Date: 5th December 2022

RE: RESPONSE TO REQUEST FOR FURTHER INFORMATION IN RESPECT OF A PLANNING APPLICATION FOR DEMOLITION OF EXISTING FLAT ROOF EXTENSION TO THE REAR; CONSTRUCTION OF A PART SINGLE-STOREY FLAT ROOF, PART TWO STOREY PITCHED ROOF EXTENSION, WHICH IS PARTIALLY SUNKEN TO THE REAR, WITH TWO ASSOCIATED ROOFLIGHTS; REPLACEMENT OF THE FRONT EXISTING PVC WINDOWS WITH TIMBER FRAME WINDOWS; WIDEN EXISTING VEHICULAR ENTRANCE, CREATION OF A NEW PARKING AREA TO THE FRONT OF THE PROPERTY AND NEW FRONT STONE BOUNDARY WALL, TOGETHER WITH ALL ASSOCIATED SITE, LANDSCAPING AND ANCILLARY WORKS TO THE SITE LOCATION IN AN ACA, AT 636, WHITECHURCH ROAD, RATHFARNHAM, DUBLIN 16

SOUTH DUBLIN COUNTY COUNCIL REG. REF: SD22B/0357

Figure 1: Extract from Adrian Hill Architects Dwg. No. P(400)

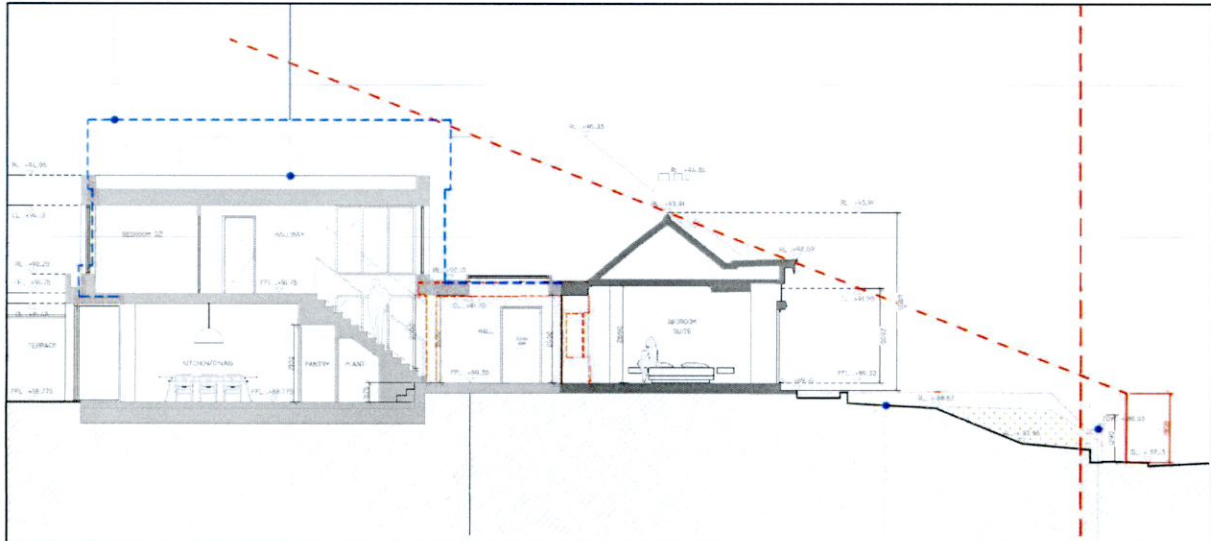
(a). The height should be reduced and kept within the ridge line of the existing cottage.

- 3.3 The scheme as amended in this response to the request for further information incorporates a reduction in height of the proposed extension from 7.2 metres as originally submitted to a maximum of 5.6 metres as now proposed.

- 3.4 The finished floor level has been reduced to facilitate a lower building height relative to the existing dwelling and a flat roof has been introduced.

- 3.6 It is respectfully submitted that the reduction in height strikes an appropriate balance between the needs of the family for the extended home and the conservation requirements of the area, ensuring that the roof profile of the new extension will not be visible from the front elevation of the property. The dominance of the existing bungalow is therefore maintained.

Figure 2: Extract from Adrian Hill Architects Dwg. No. PL(200)

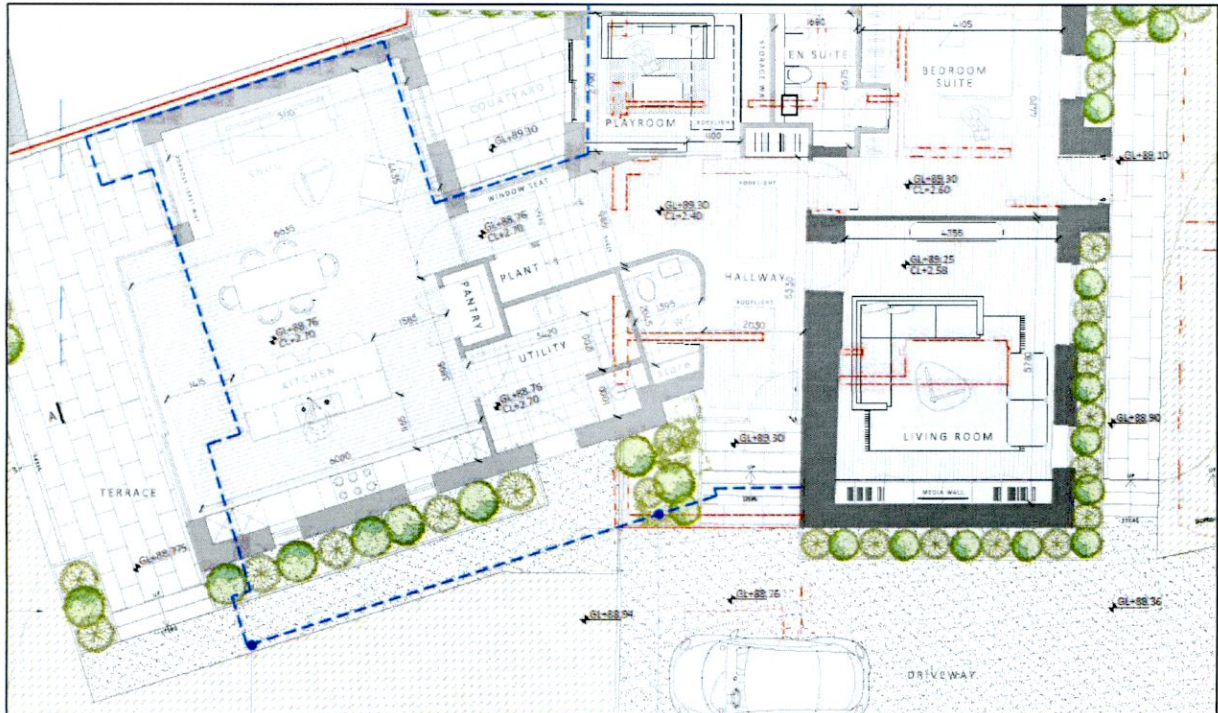
(b). The layout of the proposed extension should also be set back within the side building line.

3.9 Based on the request for further information, further steps have been taken to ensure that the proposed extension sits behind the southern gable line of the existing dwelling, meaning that the proposed extension will appear as a secondary or subsidiary element.

3.10 The building footprint to the south has been moved back (northwards) to be offset from, and subservient to, the existing bungalow (refer to image below, the dashed blue line being the originally proposed building line). This, coupled with the single storey transition
